# 1966 Corvette: Product Data Book: Radiator Grille Supports

**Subject:** Radiator Grille Supports

**Model and Year:** 1966 Corvette

**Source:** Technical Service Department - Product Data Book

**FIGURE 1**

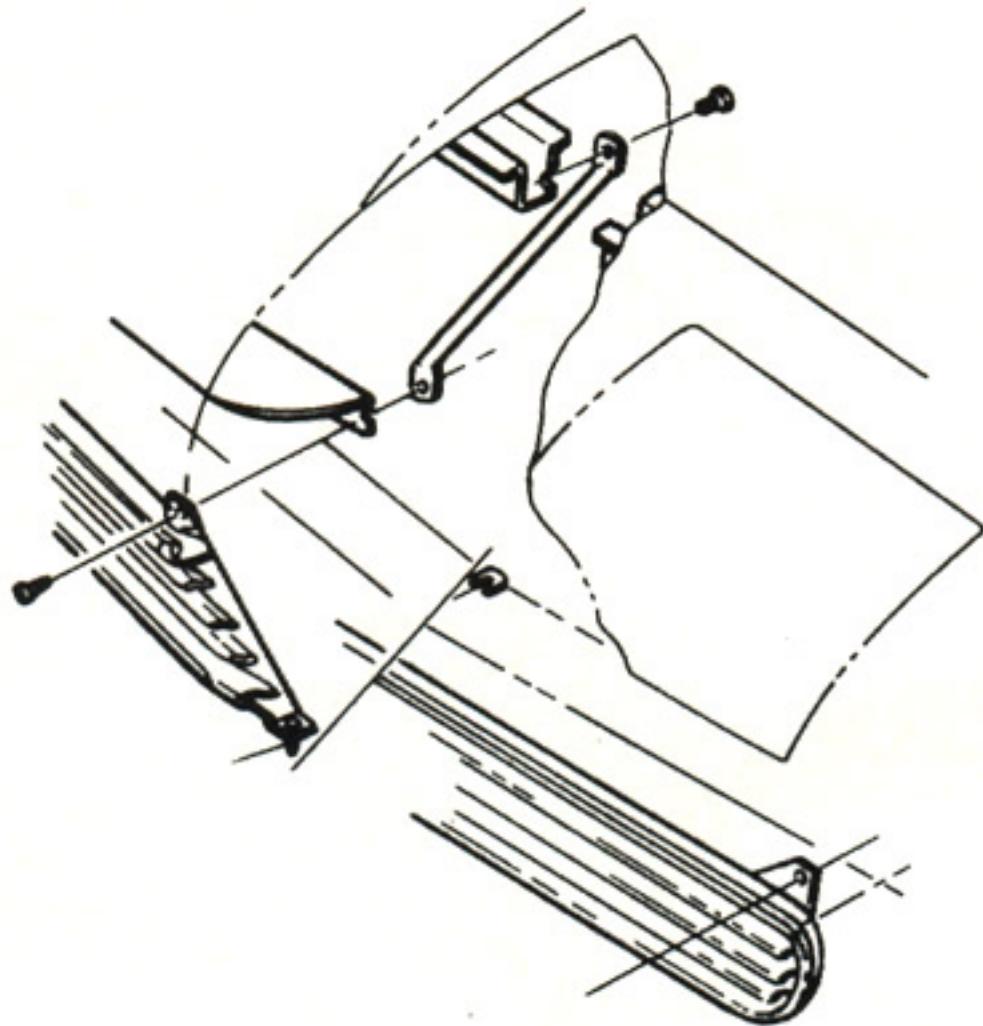
When 1966 Corvettes are driven on rough surface roads, there is a possibility the outer grille supports may break at the body attaching locations.

In production, starting with serial #S115499, the radiator grille supports are of an improved design and a radiator support rod has been added at the center. This is similar to 1965 production.

If outer grille support breakage is encountered on vehicles built prior to serial #S115499, install radiator grille supports, Part No. 3897389, and center radiator support rod, Part No. 3897387. (fig. 1).
